SITE INSPECTION SHEET

OWNER: _____ PHONE #: 410-419-3273
ADDRESS: 10981 Scaggsville Rd. CONTRACTOR: Paul Arnold
_____ WELL TAG #: _____
SUBDIVISION: _____ LOT: _____ COUNTY #: _____
PROPOSAL: Refinish basement after water damage.

(10981 Scaggsville Rd.)

LOCATION DIAGRAM

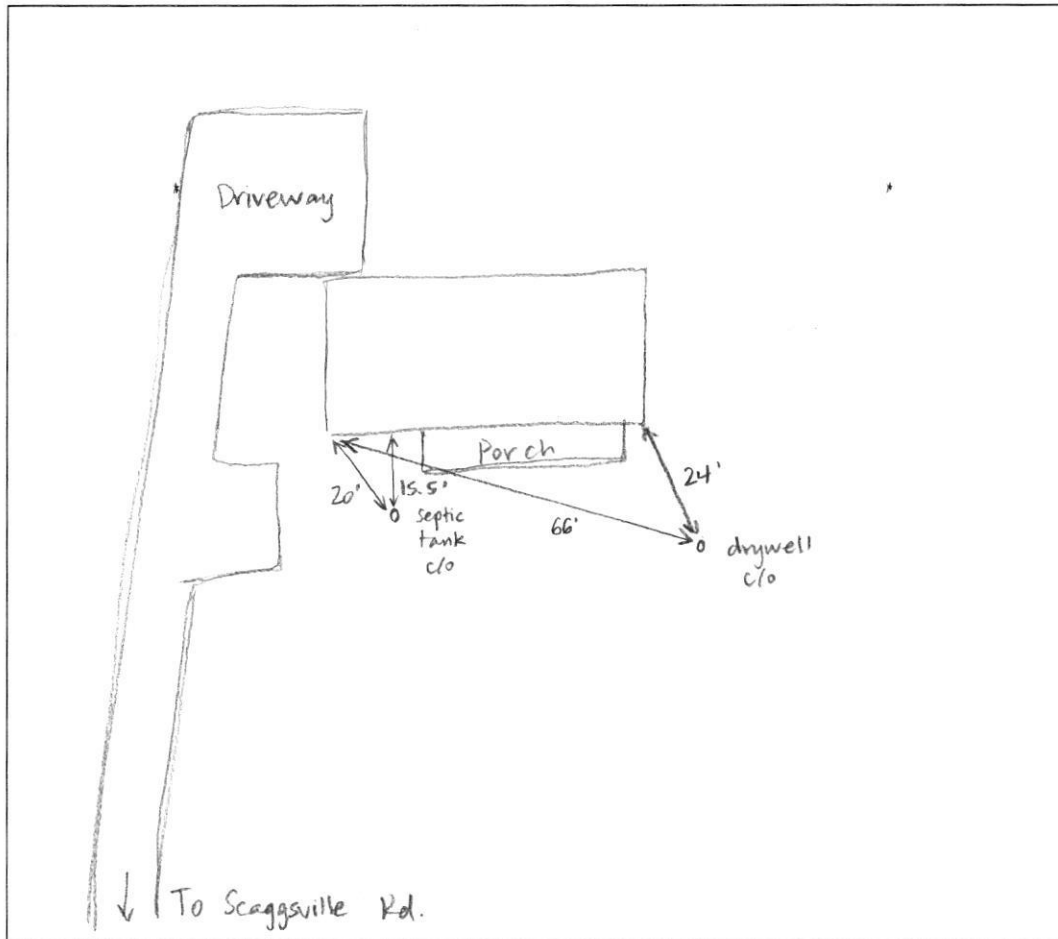
COMMENTS: Drywell measured - 11' to bottom. 32" to liquid from
grade. Septic tank is 29" to scum/liquid from grade.
